**MFN 06-041**

NEDO-32983-A, Revision 2

# **General Electric Methodology for Reactor Pressure Vessel Fast Neutron Flux Evaluations**

**SUBJECT: FINAL SAFETY EVALUATION REGARDING REMOVAL OF METHODOLOGY LIMITATIONS FOR NEDC-32983P-A, "GENERAL ELECTRIC METHODOLOGY FOR REACTOR PRESSURE VESSEL FAST NEUTRON FLUX EVALUATION" (TAC NO. MC3788)**

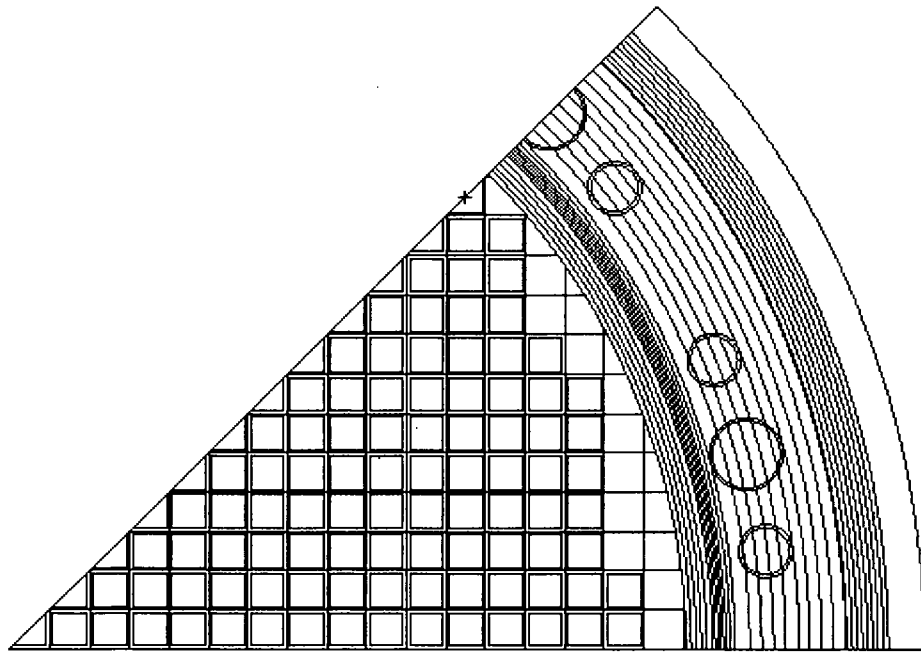
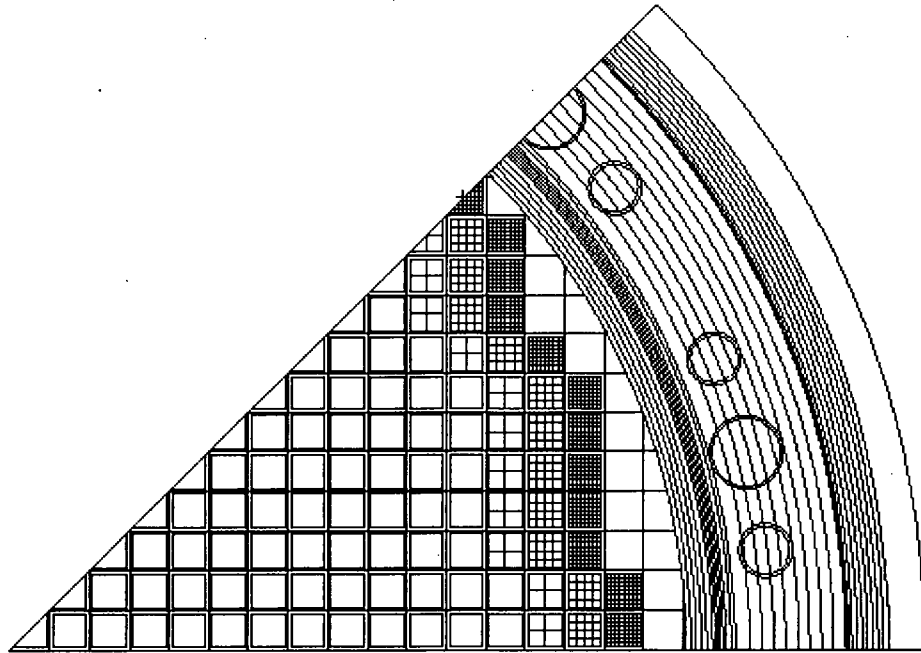
*Provide an explanation for the radially-dependent bias in the benchmark experiment C/M data of Figures 5-4, 5-5 and R9-1. Does this indicate that calculations based on the proposed methodology will over-predict the fluence at locations inside the vessel inner-wall? Provide justification for not including this bias in the calculation methodology. In view of the data in Figure 9-1:*
